REMARKS

Amendments to the Drawings:

FIG. 1

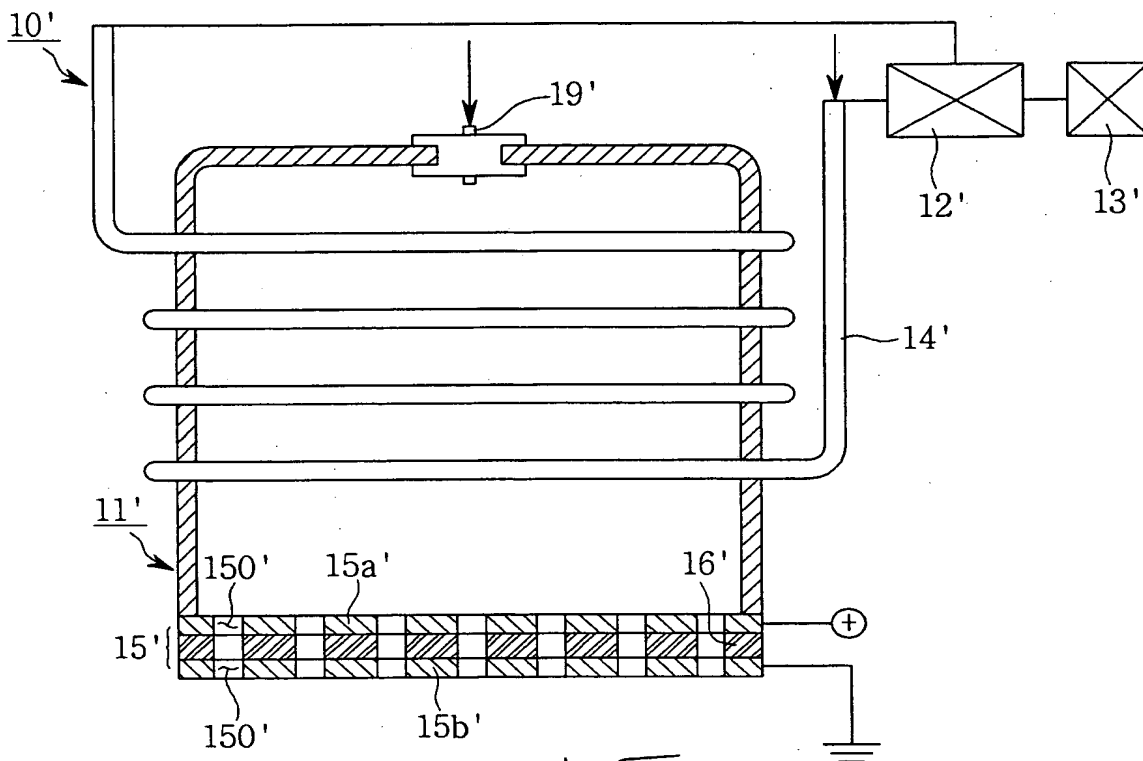
The Office Action indicated that the Figures 1, 2A and 2B should be designated by a legend such as --Prior Art--. Applicants have amended Figures 1, 2A and 2B to label them as "PRIOR ART".

The specific changes which have been made to Figures 1, 2A and 2B is to include the legend "PRIOR ART".
